Subject: Bulk oil remounting kit

Model Affected: LVE 304 (LOV series 300 four vat units only)

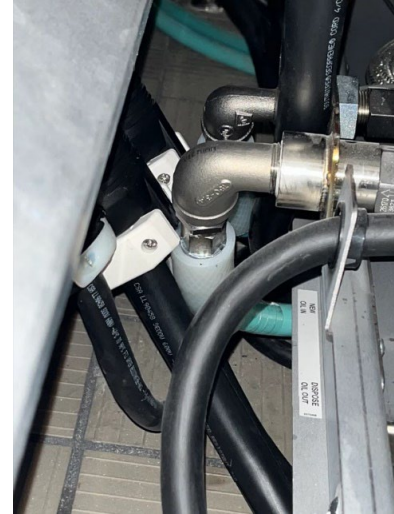
In certain installations, the bulk oil (RTI) connections at the rear of LVE-304 fryers built before LC2410145 may interfere with power cord connections (see image at right). This prevents the fryer from pushing back against the wall and allows 2-3 inches of the fryer to stick out past the front of the hood enclosure.

To resolve this issue, kit **140938** is now available which repositions the bulk oil (RTI) connections to avoid power cords at the rear of the fryer. Instructions are included with this kit and available on service.hennypennyhelp.com: [Bulk Oil Retrofit Move](#)
